Proposed Site & Management Plan for the New Operations Facility at Jersey Airport

TECHNICAL REPORT

Prepared by International Services, UK Civil Aviation Authority

Report on the Proposed Site and Management Plan for the New Operations Facility at Jersey Airport

Freight Taxiway Centreline

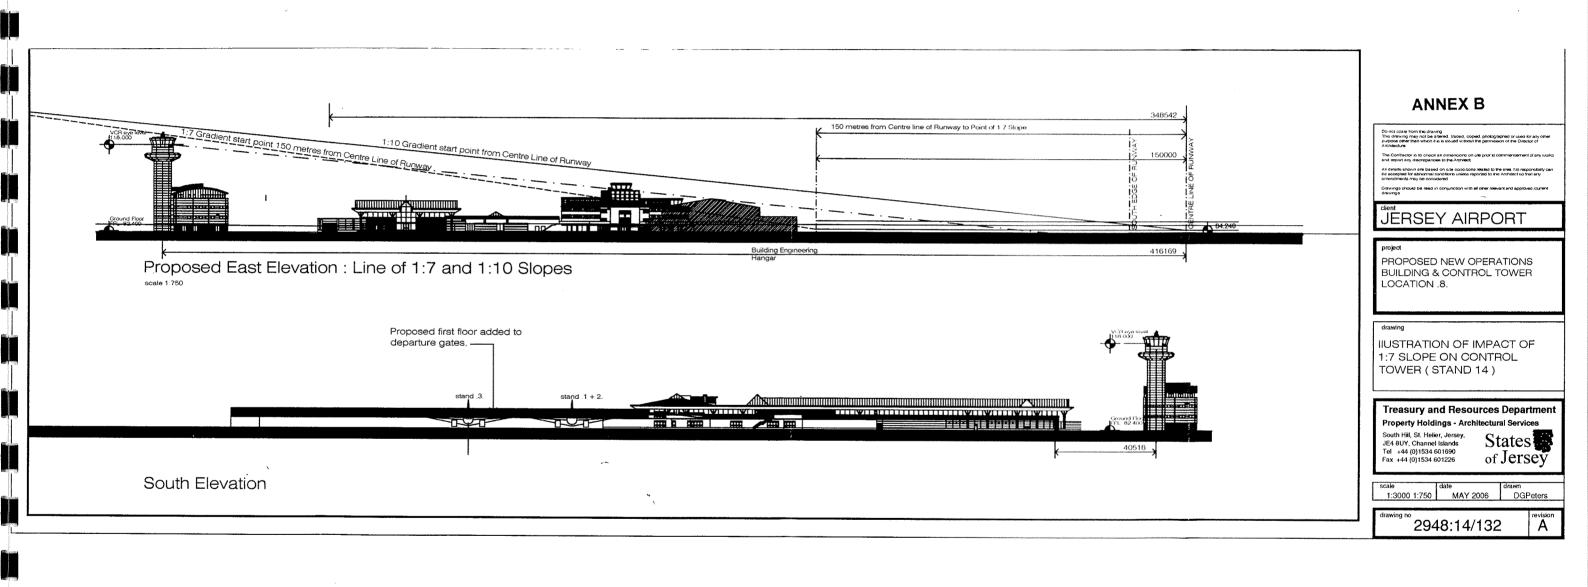
- Initially there will be some obscuration of the Echo and Alpha taxiways, which will be addressed once the upper floors of the 1937 building have been removed.
- If a second floor is built onto the existing terminal pier, there will be some minor obscuration of the North Apron stands that can be satisfactorily overcome by the use of CCTV and an appropriate management plan.
- The Taxiway to the freight apron will have to be realigned in order to construct the building, however, it is noted this taxiway is due for replacement due to age deterioration.
- The Obstacle Clearance Height (OCH) for the NDB/DME for Runway
 27 will need to be increased by 10ft, in itself a minor issue.
